TP306983 MODIFICATION KIT

APPARATUS AFFECTED: 28LA Apparatus Cabinet.

OBJECT: To increase the filament life of the copylights by decreasing vibration.

FIGURE 1A.

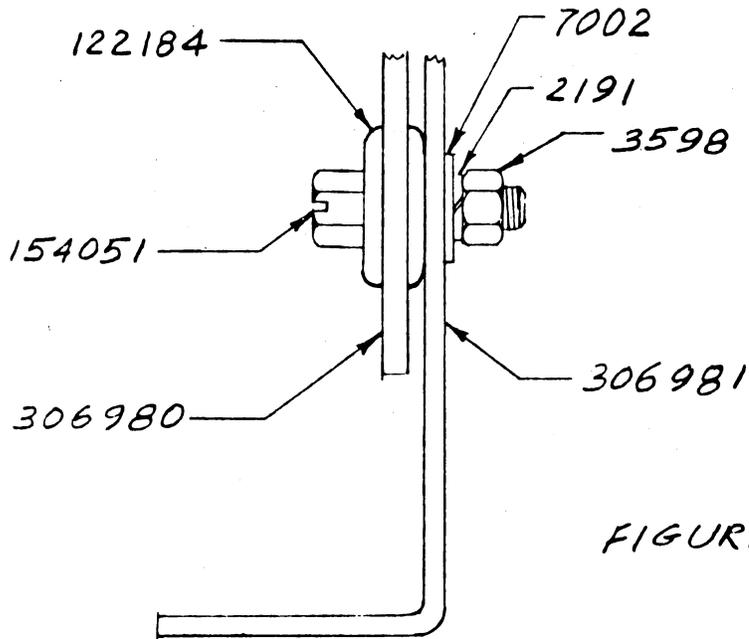
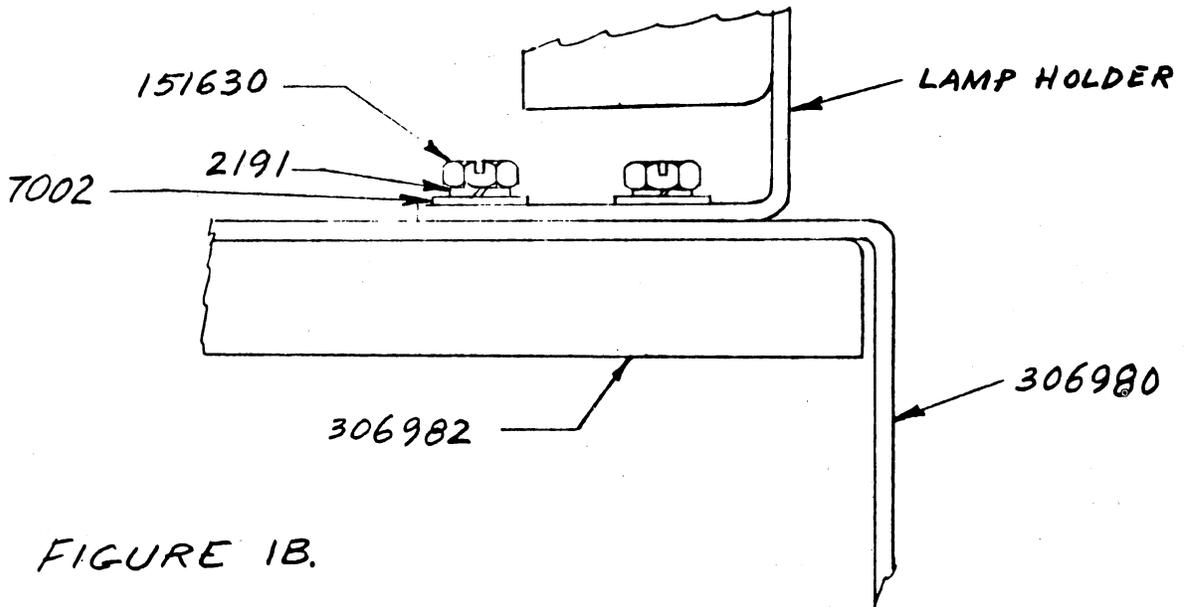
CHANGE: (Figure 1) The TP145476 copylight bracket has been replaced by the TP306980 upper bracket, TP306981 lower bracket, and the TP306982 bar. The TP306980 upper bracket and the TP306981 lower bracket are connected by means of TP154051 shoulder screws and the existing hardware.
